Dowe Flats Mine / M1993-041 / TR-4 / Adequacy Review #3 - Bond Estimate

RE: Dowe Flats Quarry, Permit No. M-1993-041, Technical Revision #4, Adequacy Review No. 2 Response

Figure 1: Average Reclamation and Reference Area Vegetation Cover (2011-2019)

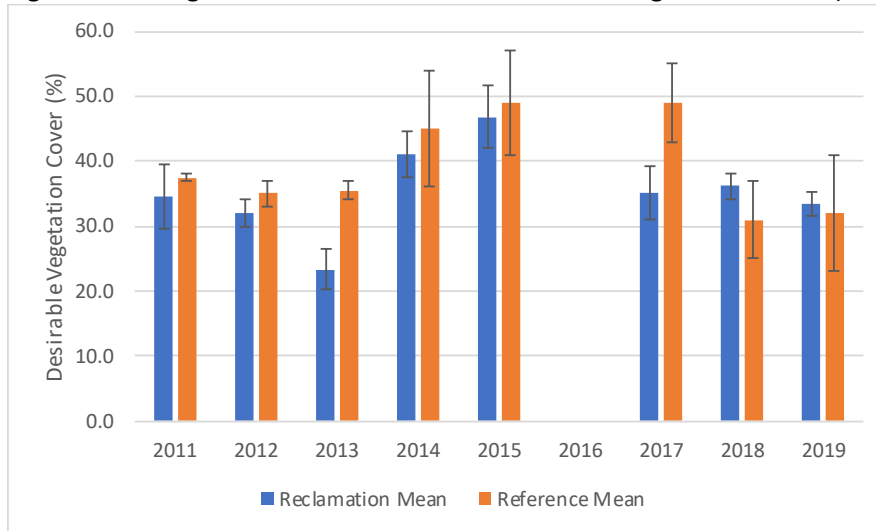
- 3) The seeding failure rate of 30% is much higher than expected. The most common rate found in a review of seeding specifications is 10% which is the value we used in our estimate. CEMEX has been conducting interim vegetation monitoring on the previously completed reclamation at the Dowe Flats Quarry in most years since 2011 and comparing the data to a nearby reference area inside the permit boundary but outside the affected area. In six of the eight years of monitoring, the average desirable vegetation cover of the reclamation area samples is equivalent to or greater than the reference area (Figure 1). The vegetation cover also persists well after the first few years of growth (Figure 2). Given the success of reclamation efforts to date, we believe that the 10% failure rate in our initial calculations was more appropriate.
